Final Drainage Report

UDON South El Paso County, Colorado

PPR2422

Prepared: June 26, 2024

UDON SOUTH - EXISTING DRAINAGE EXHIBIT

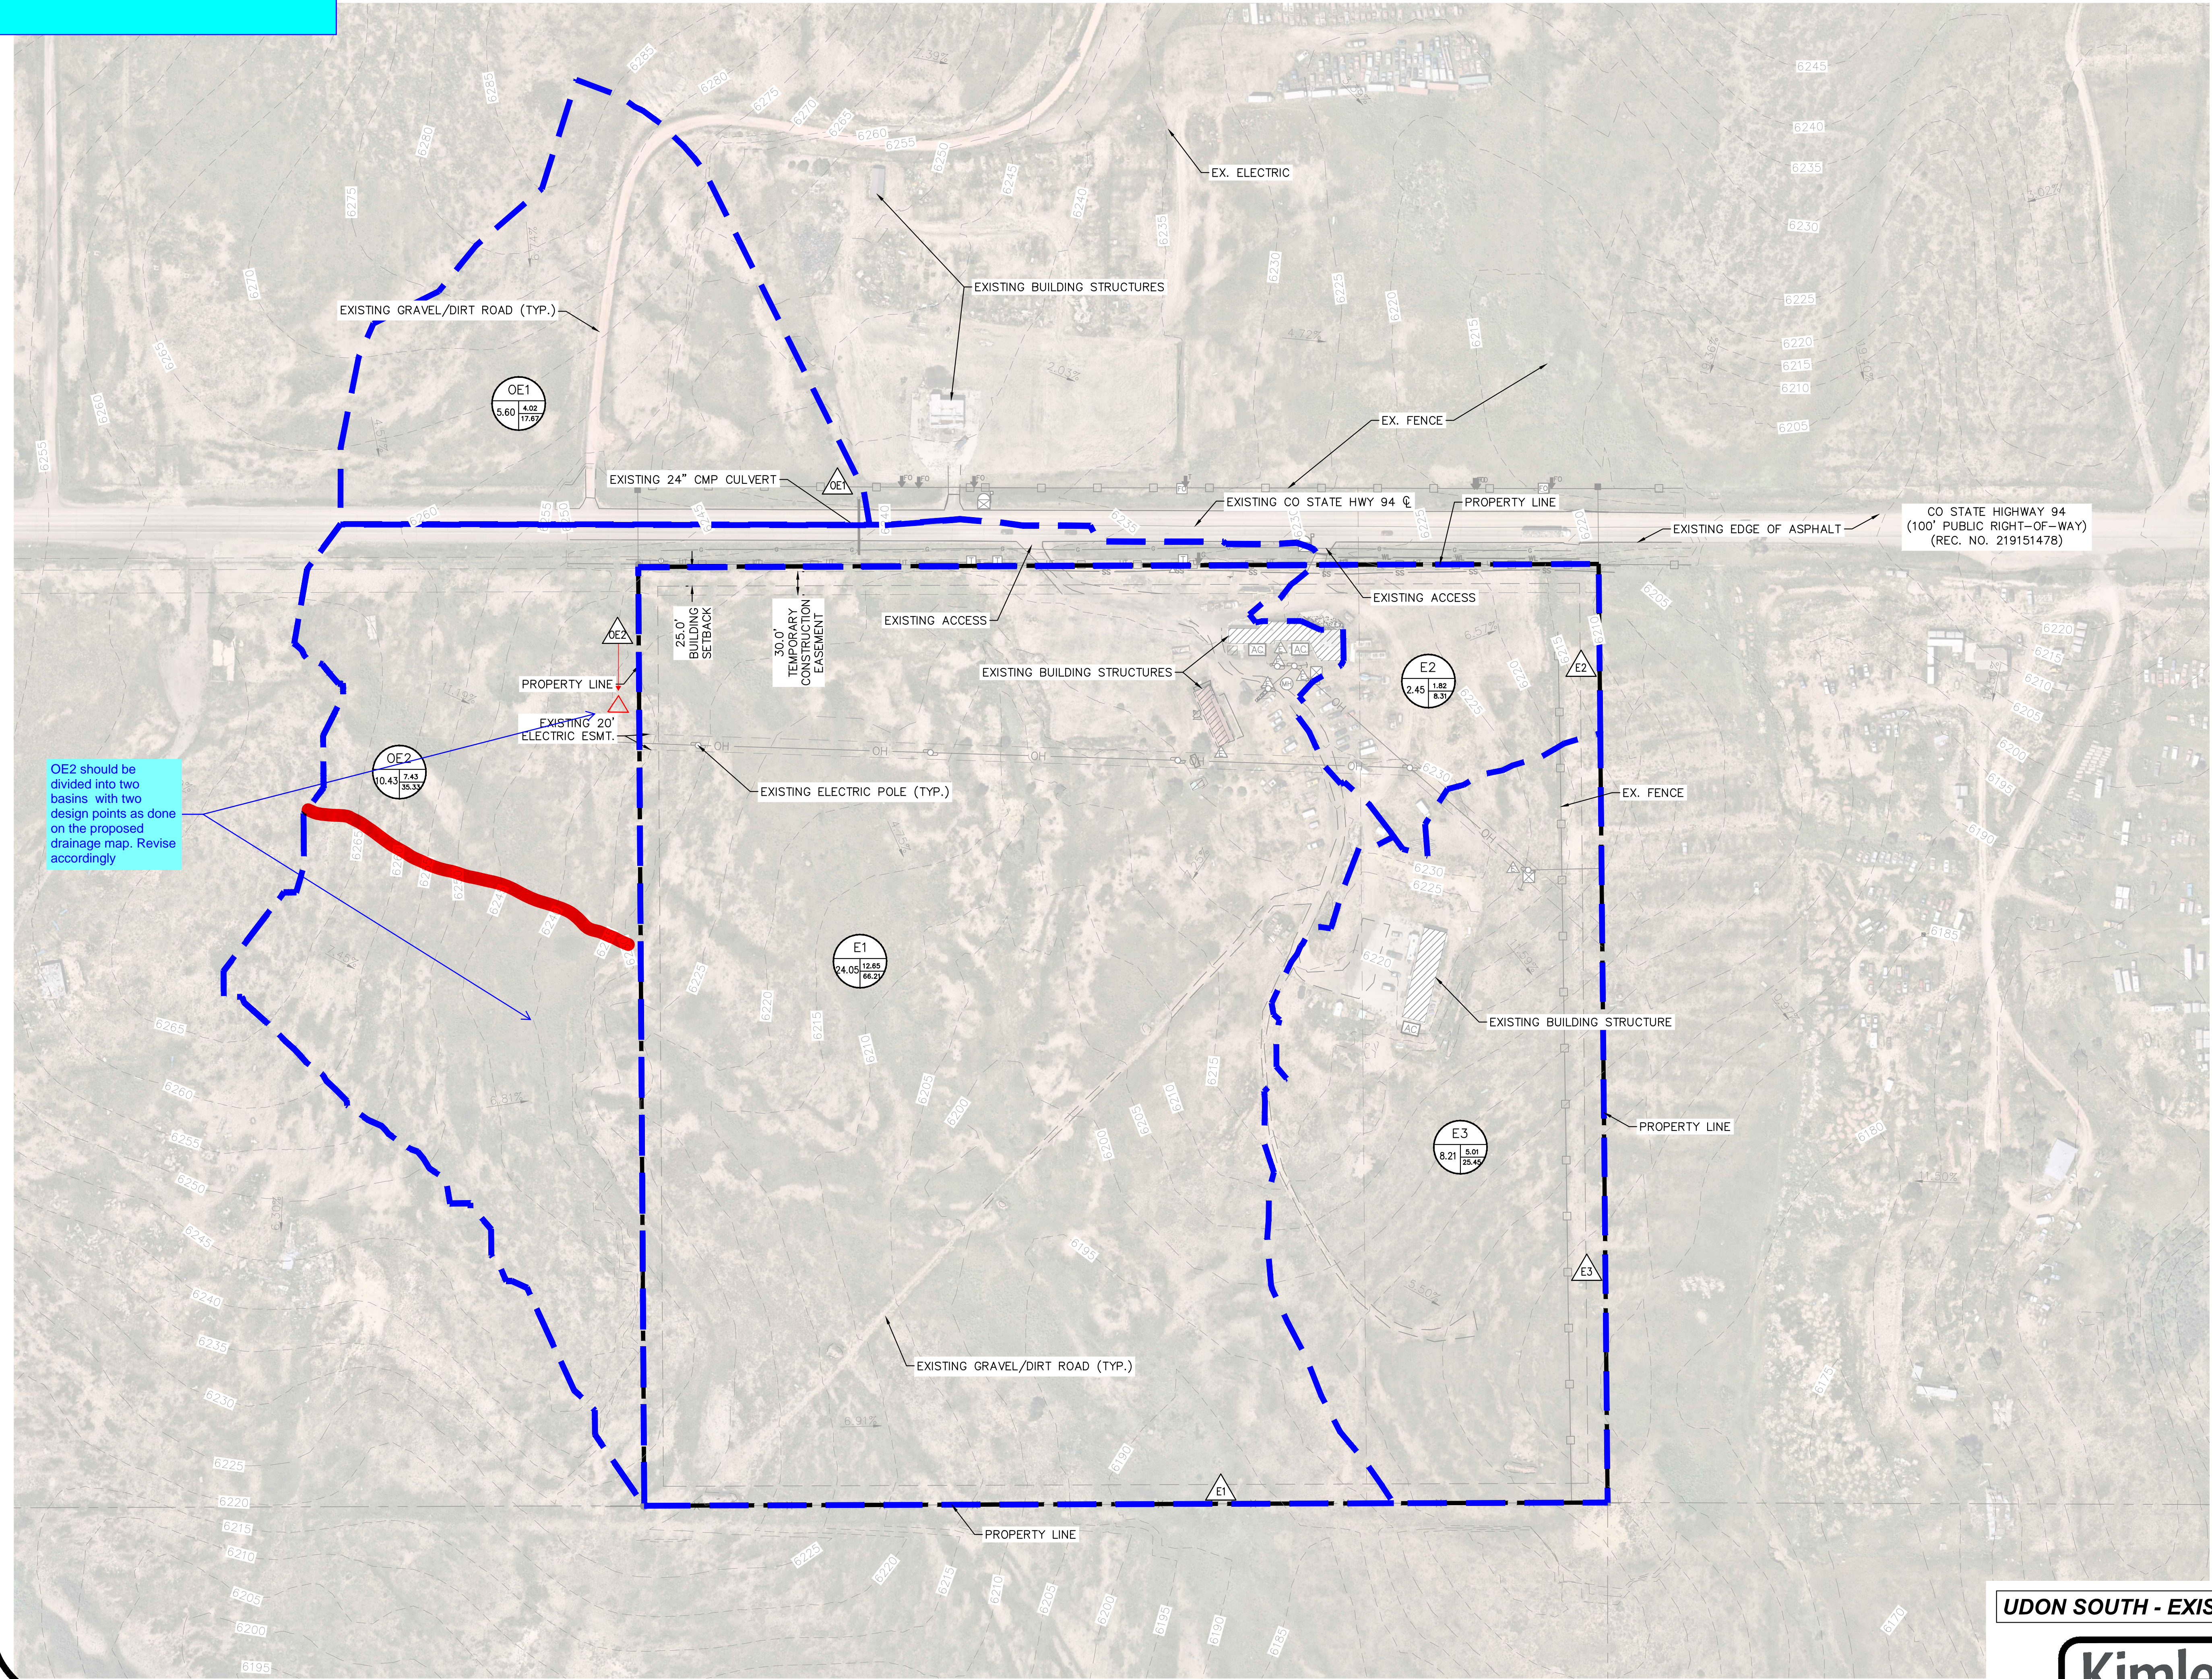
OE2 should be divided into two basins with two design points as done on the proposed drainage map. Revise accordingly

Engineering Profile - North Culvert - 5YR (UDON South North Culvert - StormCAD.stsw)

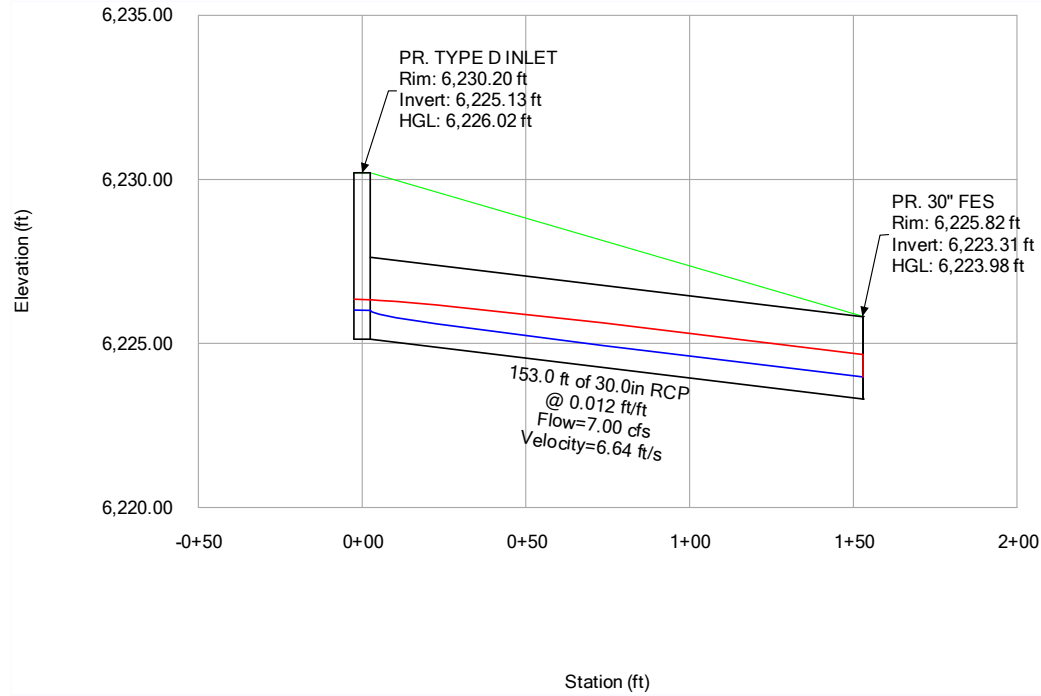
Add tailwater values to results table.

Engineering Profile - North Culvert - 100YR (UDON South North Culvert - StormCAD.stsw)

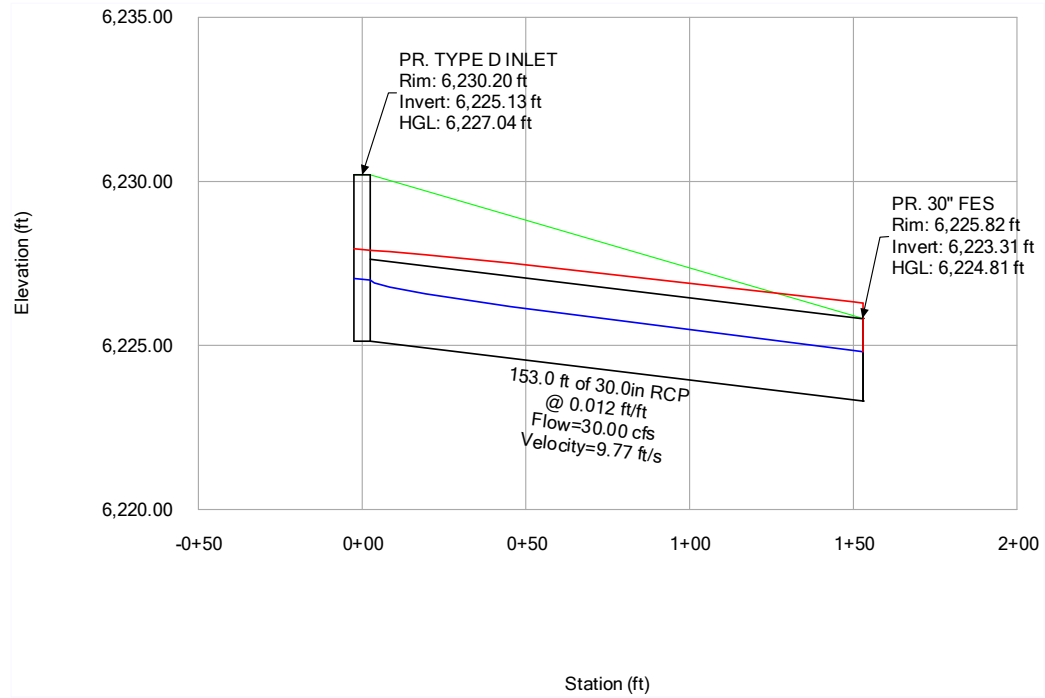
Add tailwater values to results table.

DETENTION BASIN OUTLET STRUCTURE DESIGN

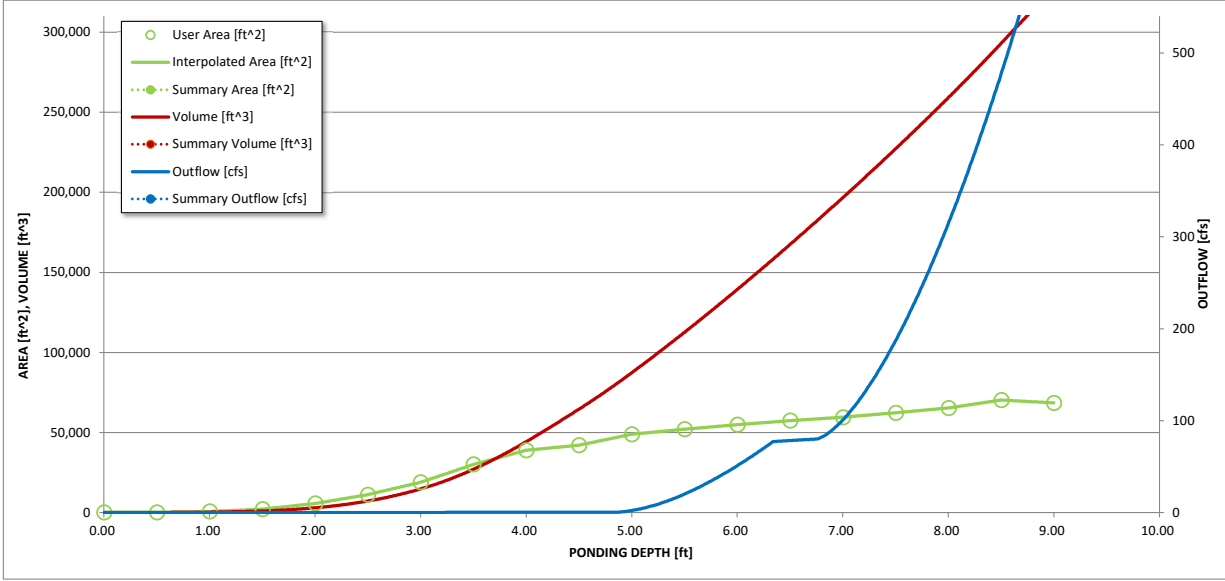
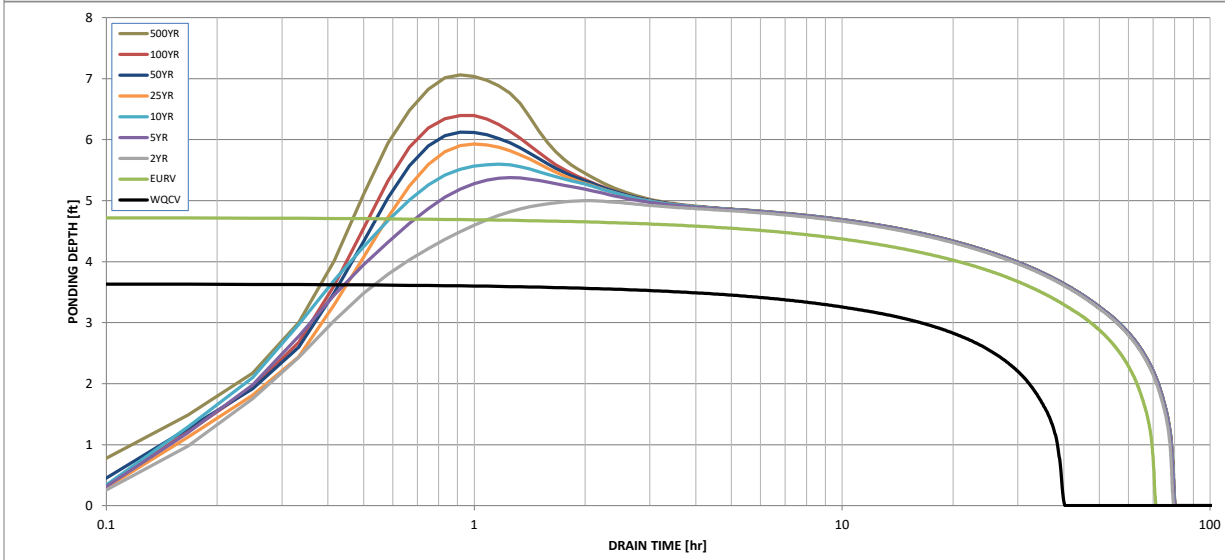
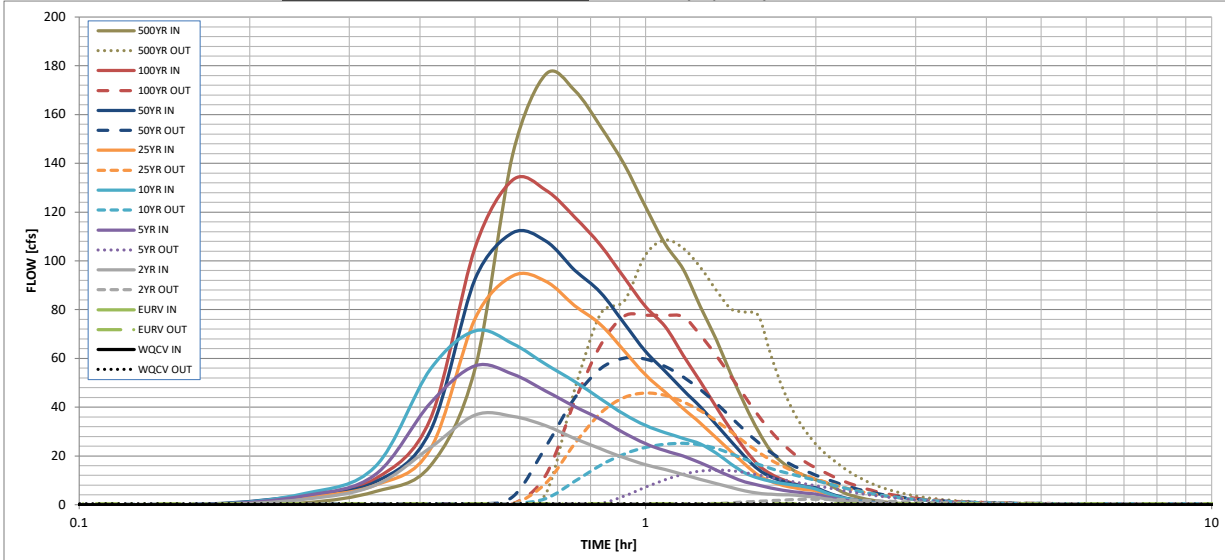
Adjust design to meet the 40-hr requirement, fixing the orifice numbers may help
